INNER WEST COUNCIL

DEVELOPMENT ASSESSMENT REPORT

Application No.	201800302
Address	2 Bourne Street, Marrickville
Proposal	To demolish part of the premises and carry out ground and first floor alterations and additions to a dwelling house, install a pool in the rear yard and a new parking space at the front of the site
Date of Lodgement	16 July 2018
Applicant	Mr H Alvarez
Owner	Ms M Nestoriadis & Ms P M Quinn
Number of Submissions	Nil
Value of works	250,000
Reason for determination at Planning Panel	The development involves the partial demolition of a heritage item
Main Issues	Heritage; Parking Design; Landscaping
Recommendation	Consent subject to conditions
Attachment A	Recommended conditions of consent
Attachment B	Plans of proposed development
Attachment C	Statement of Heritage Impact

Image 6: Extract of proposed hardstand area with measurements

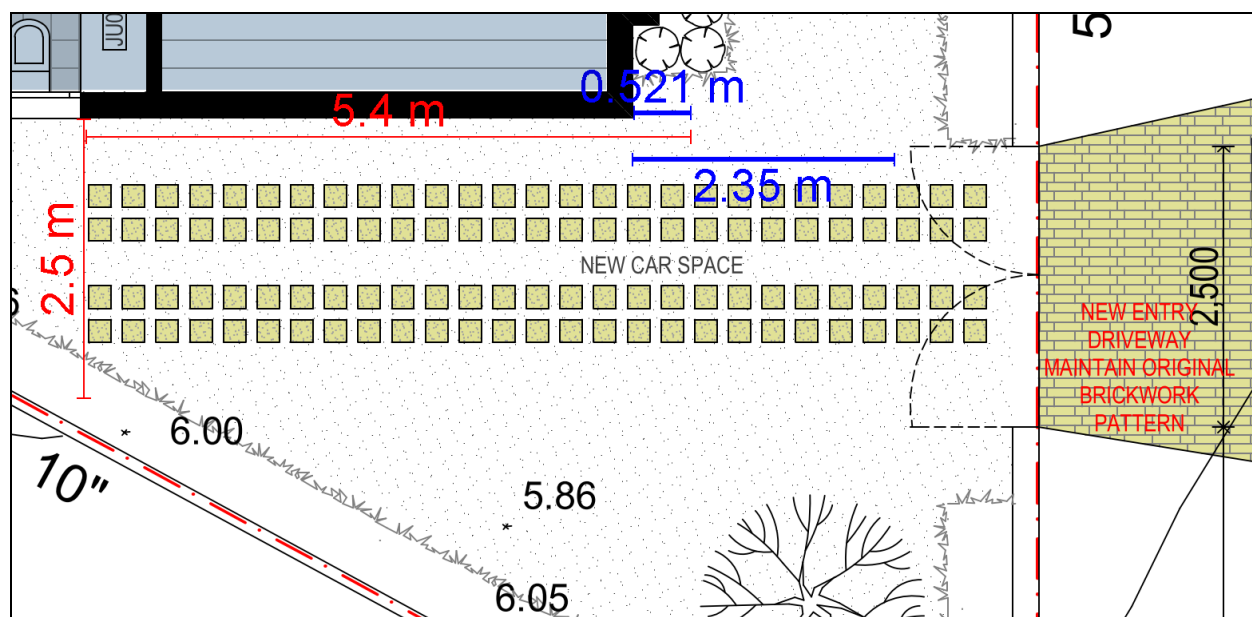
While the proposal generally complies with these requirements, Control 17 states that car parking structures forward of the building line are not permitted. The proposal includes a hardstand car parking area that will project a minimum of approximately 500mm forward of the front building line, and possibly up to approximately 2.3 metres forward of the building line. As such, the proposal does not strictly comply with this requirement.

Notwithstanding, Control 18 does allow Council to consider car parking structures forward of the building line providing such a structure does not impact landscaping at the front of the site; is integrated into the landscaping and is semi-pervious; does not require alterations to the dwelling; is located 600mm from a boundary fence to allow for access and landscaping; and any new vehicle crossing does not adversely impact the streetscape and is consistent with surrounding hardstands.

As such, while the proposed hardstand car parking space will project forward of the building line, the hardstand is considered acceptable for the following reasons:

- The hardstand area has been designed to incorporate landscaping, will not dominate the front of the property and is semi-pervious incorporating spaced paving and wheel strips only;

- The hardstand does not require structural alterations to the period dwelling and is located on the southern side of the dwelling;
- The hardstand is generally 600mm from the southern boundary fence and maintains the capacity for landscaping;

- The proposed hardstand is visually unobtrusive and does not include a carport or garage structure that would present bulk to the street;
- A number of other dwellings within Bourne Street exhibit hardstand areas to the side or partially to the front of properties; and

- Despite the impact to the adjoining heritage footpath, which has been discussed earlier in this report, the new driveway crossing would not result in adverse impacts to the streetscape and would be generally consistent with driveway crossings in Bourne Street.

21. The internal vehicle hardstand area shall be redesigned such that the level at the boundary shall match the invert level of the adjacent gutter plus 110mm/150mm at both sides of the vehicle entry. This will require the hard stand area to be adjusted locally at the boundary to ensure that it matches the above issued alignment levels. Amended plans shall be submitted to and approved by Council's Development Engineer before the issue of a Construction Certificate.

22. Before the issue of the Construction Certificate, the vehicular crossing and driveway ramp to the site shall be designed to satisfy the ground clearance template (Figure C1) from Australian Standard AS/NZS 2890.1-2004 *Parking Facilities: Off-street car parking*. Amended plans shall be submitted to and approved by Council's Development Engineer before the issue of a Construction Certificate.

23. Drawings shall be amended to include the Design Envelope shown in figure 5.2 of the AS 2890.1:2004. These minimum space requirements must be accommodated by the proposed hardstand. The vehicular crossing shall be widened to the south to be 3 metres wide at the boundary, and shall have a reinforced concrete base with the heritage pavers laid on top with a mortar bed. Amended plans shall be submitted to Council before the issue of the Construction Certificate.
